Your Comment on the Foxton Solar Farm application

Comments on a fast-track consenting application

Regarding fast-track project: Foxton Solar Farm

Fast track Reference: FTAA-2510-1121

Figure 1: Australasian bittern eBird records (blue markers) in the vicinity of the proposed solar farm (red ellipse). Accessed 29 May 2026.

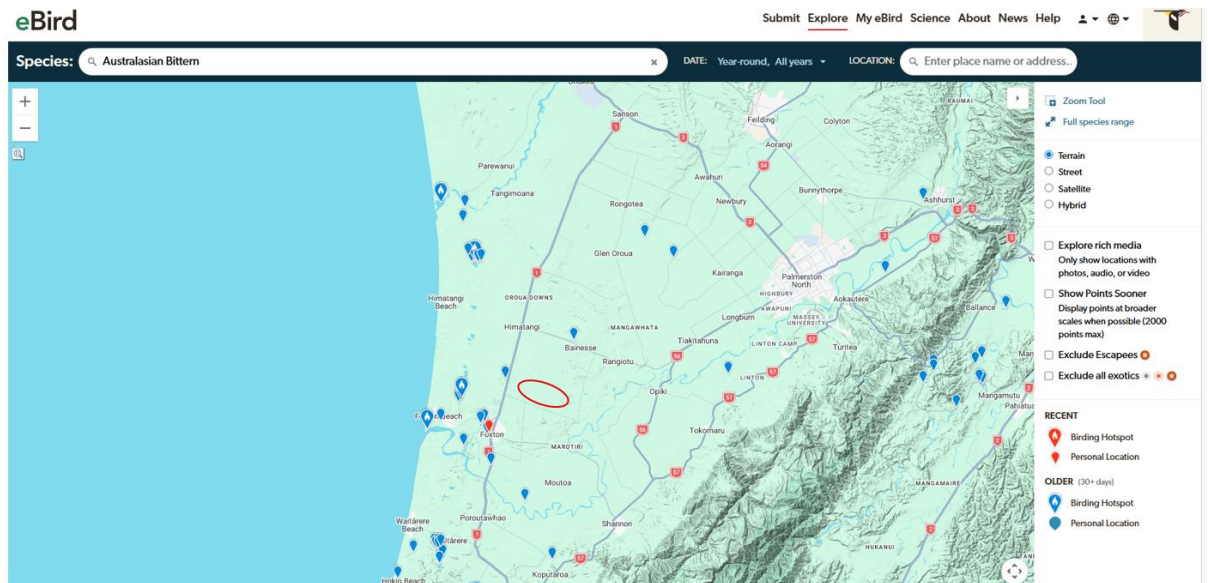
- 3.4 In particular, Australasian bittern have been recorded in a variety of locations around the site. They are highly mobile among networks of wetlands, and must travel between the recorded locations, so are likely to overfly the site. As wetland birds, they could also make

use of the wetlands on site and in the near vicinity. Overseas research has shown other bittern species, similar to the Australian bittern, have collided with solar farms.³

- 3.7 That survey approach would be highly unlikely to have detected Australasian bittern even if they were present or flying over the site in that period. Australasian bitterns are a cryptic species (their plumage, behaviour and habitat use make them hard to detect even under ideal conditions), they are largely silent except for males calling from dusk during the breeding season, and most of their feeding and movement activities occur at night. DOC's experience is that Australasian bittern are hard to detect even for highly experienced

- 3.8 This means that the EIA cannot inform whether Australasian bittern use the site for foraging – noting the wetlands on site contain food for bittern - and has likely underestimated the risk of collision for avifauna, and Australasian bittern in particular as they are recorded as being in the area. The Horizons Regional Council ecological report (HRC Report) does not appear to have specifically considered Australasian bittern.
